# OCP NIC 3.0 Design Specification

Version 0.530-59

Author: OCP Server Workgroup, OCP NIC subgroup

Figure 5: Example Large Card Form Factor

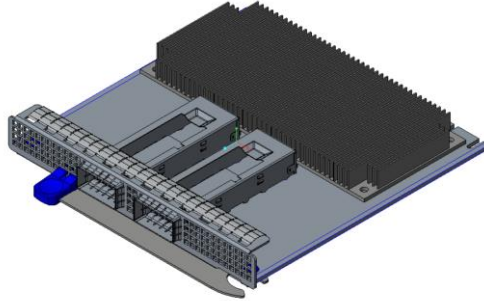
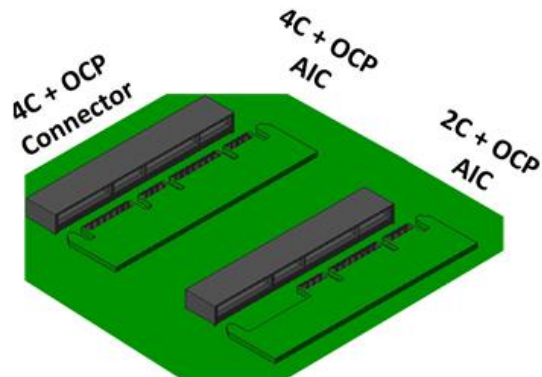
**Commented [HS2]:** For some use cases, secondary connector is not required to be used for large card size. We need to discuss and clarify it.

**Commented [TN3R2]:** I made a place holder for a Large Card that only uses the Primary Connector. See the end of this section.
